TECHNICAL BULLETIN

Ref:TB96005	Issue No.1	Date:03/07/96	Page: 1	of: 1
Title: GL4 Stereo module modification			Authorisation: CD

GL4 Headphone Breakthrough

Subject: **GL4 Led Meter Glow**

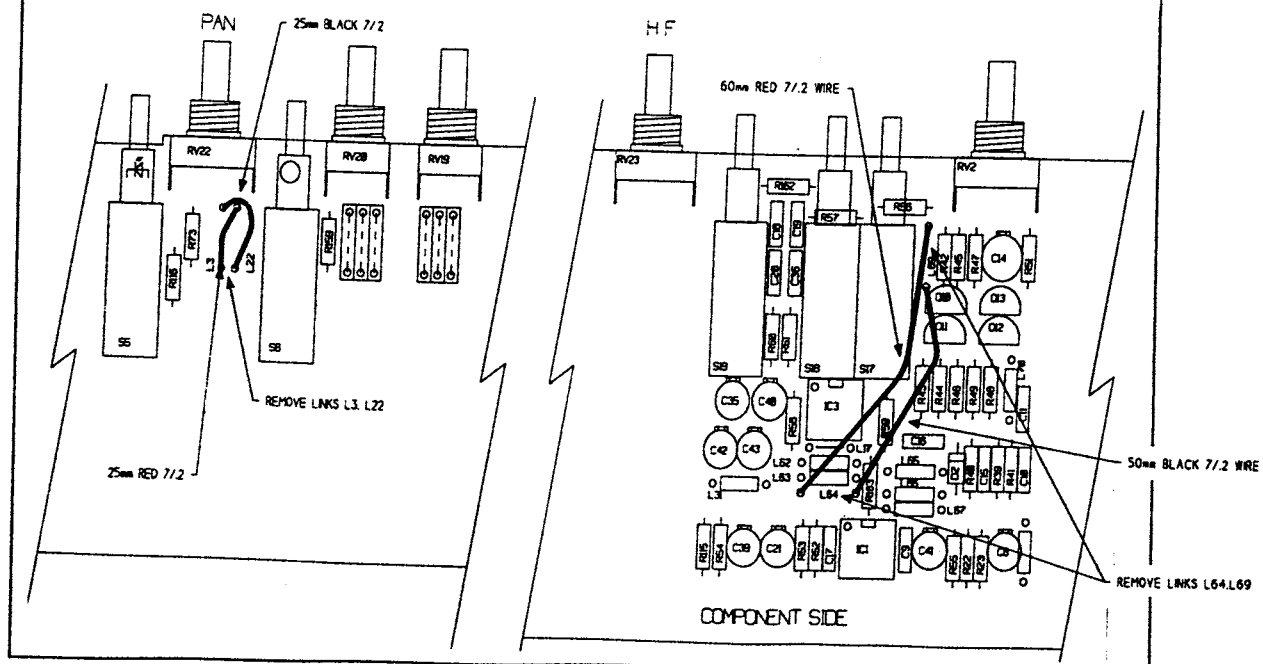
The operation of the Mono Summing switches is opposite to that denoted by the front panel graphics.

Ensure a clean, flat work surface on which to work. Remove all knobs and pot nuts from the stereo input channels. Invert the console and remove the base. Unplug and remove the stereo input PCB's and remove links L3, L22, L64 and L69 as shown below. Fit the four new wire links as shown below.

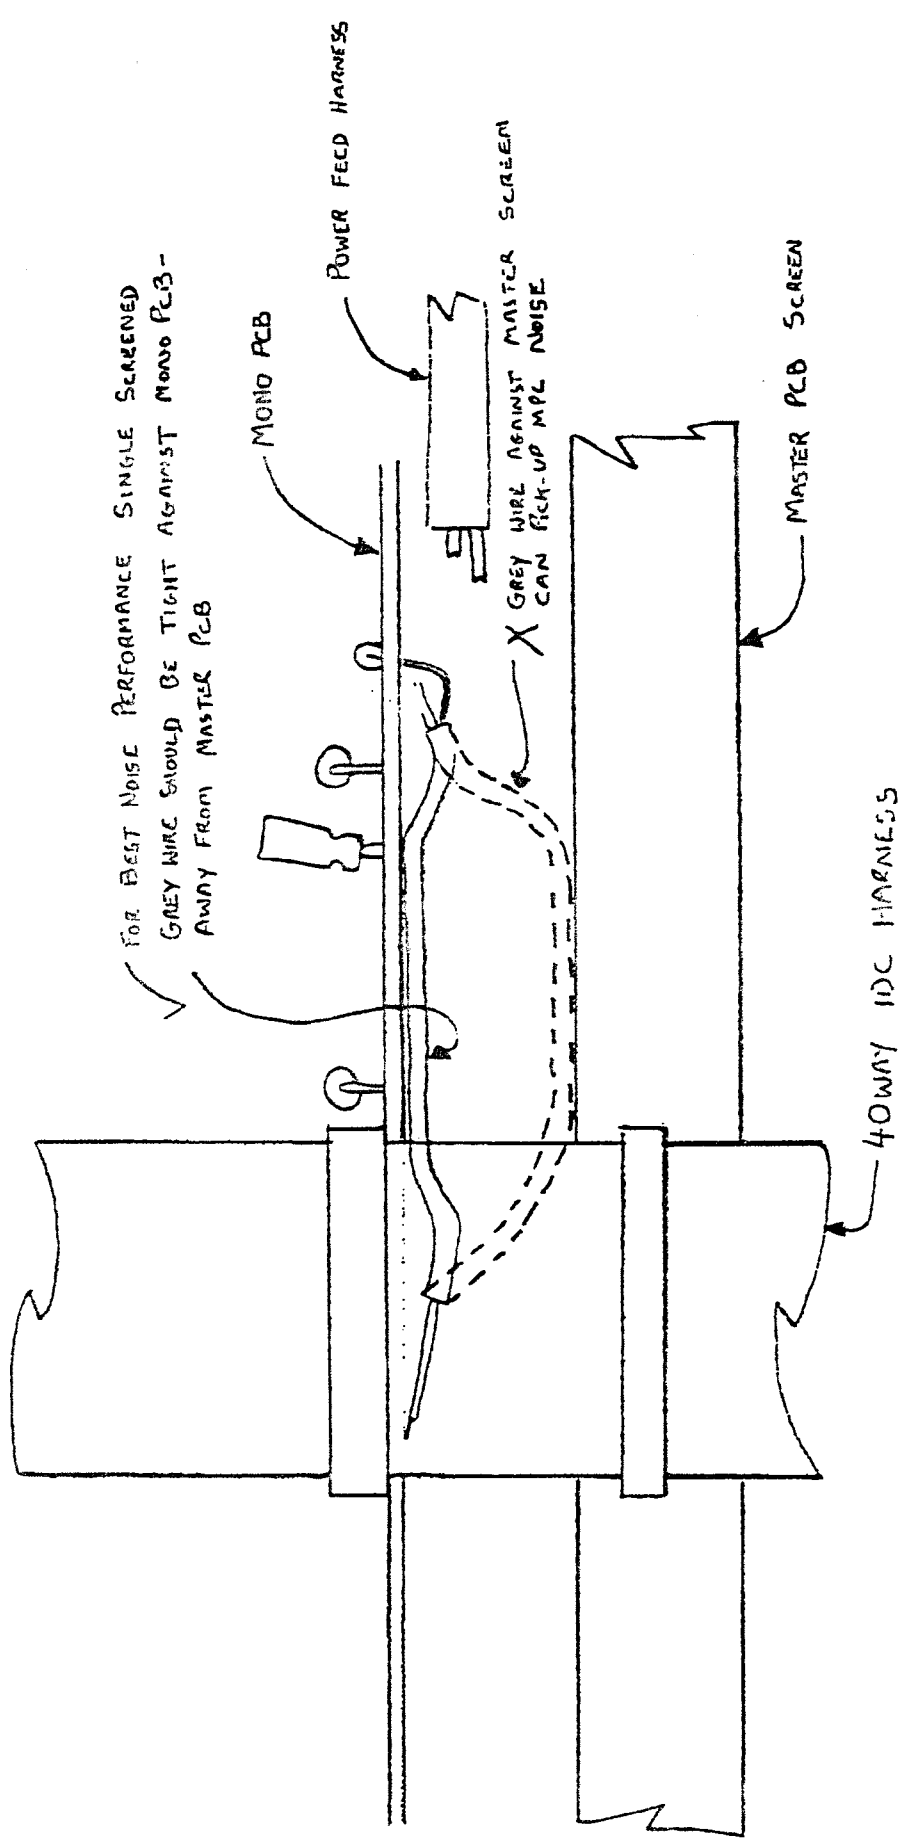
When using low impedance Headphones at high listening levels some breakthrough to left and right outputs may be detectable. This is due to modulation of the "clean" earth feeding the mix amps. To improve the level of breakthrough it is necessary to isolate the earths from both the headphone sockets, and the 47/25 headphone amp supply filter capacitors. To isolate the headphone socket earth, remove Link LK18 from the Master PCB, (see section B-24 of the service manual, LK18 is at the bottom left of Phones 2 socket SK2) then solder a length of 16/.2 wire from the Phones 1 earth point, to the earth Star point on the Power XLR input socket. Next locate capacitors C55, C56 on the Mono PCB, (section B-26 of the service manual, C55,56 are directly below the AB monitor switch S10). The negative terminal of C55, and the positive terminal of C56 need to be lifted from the PCB, then soldered together, (probably easier to remove the caps altogether, and fit new ones) and a second piece of 16/.2 wire soldered from this joint, back to the Power XLR earth Star point. Alternatively a single length of 16/.2 could be used, if a small piece of the insulation was removed to enable it to be soldered to the caps, before being taken on to the Phones 1 earth point.

FOR BEST NOISE PERFORMANCE SINGLE SCREENED GREY WIRE SHOULD BE TIGHT AGAINST MONO PCB - AWAY FROM MASTER PCB

GREY WIRE AGAINST MASTER SCREEN CAN PICK-UP MPE NOISE

Subject: **GL4 Mute Group Lock-Up**

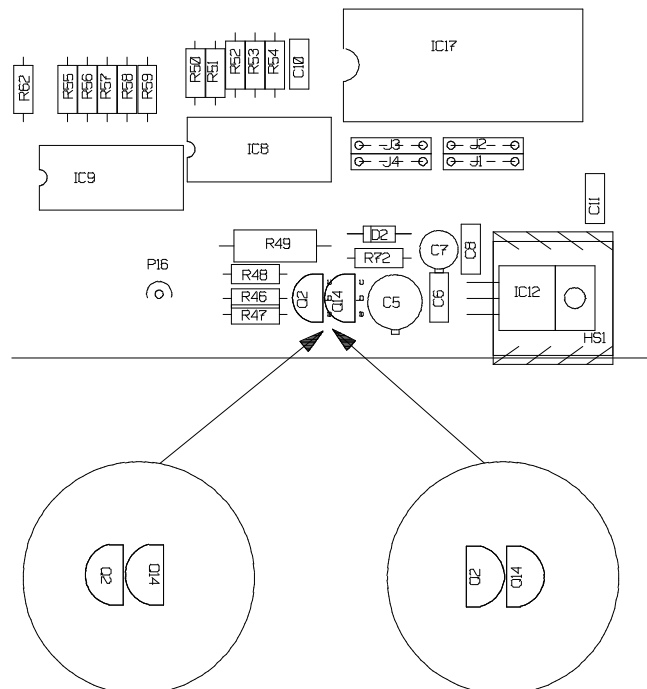
Due to a change in specification to the BC549 transistors, some production consoles will have these devices fitted reversed on the MONO PCB, AG2005A. These transistors, Q2 and Q14, are part of the power-on reset circuit for the mute processor, and although they will function in the incorrect position, they can cause the mute systems in certain consoles to lock up when first switched on from cold. Normally they will resume correct operation within a few minutes. This may be more noticeable if the DC supply voltage is lower than the +/- 16V specified.

If startup problems are encountered, then check these transistors for orientation, and reverse or replace them if necessary. With the console inverted on a suitably sized clean work surface, clear of parts and debris, and with a cloth to protect the console cosmetics, remove the base and locate the +5V regulator IC12, (identified by the black finned heatsink fitted to it) on the MONO PCB. The two transistors are to one end of the heatsink, next to a 330uF capacitor (C5). Check with the diagram and correct if needed.

NOTE The overlay in the service manual shows the *incorrect* orientation for the BC549 transistors. They should be positioned as the other transistors on the assembly.

GL4 PFL Click

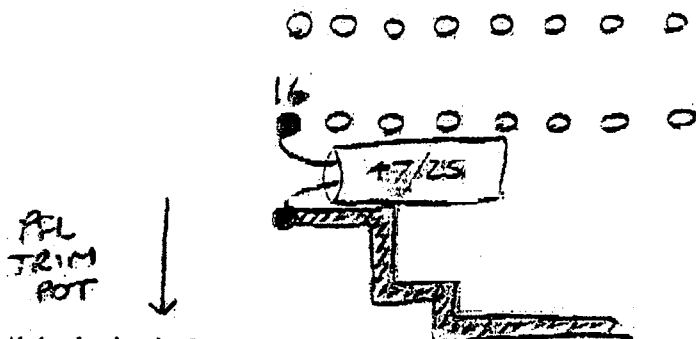
The PFL click problem occurs on some consoles and is related to component tolerances. Not all consoles suffer this. However, a simple modification to the main MONO pcb will cure this:

Solder a 47uF/25V electrolytic capacitor from pin 16 (+ve leg) of IC37 (PFL IC 4053) to 0V ground (-ve leg). The nearest 0V is the thick track below this IC towards the front panel as shown below.
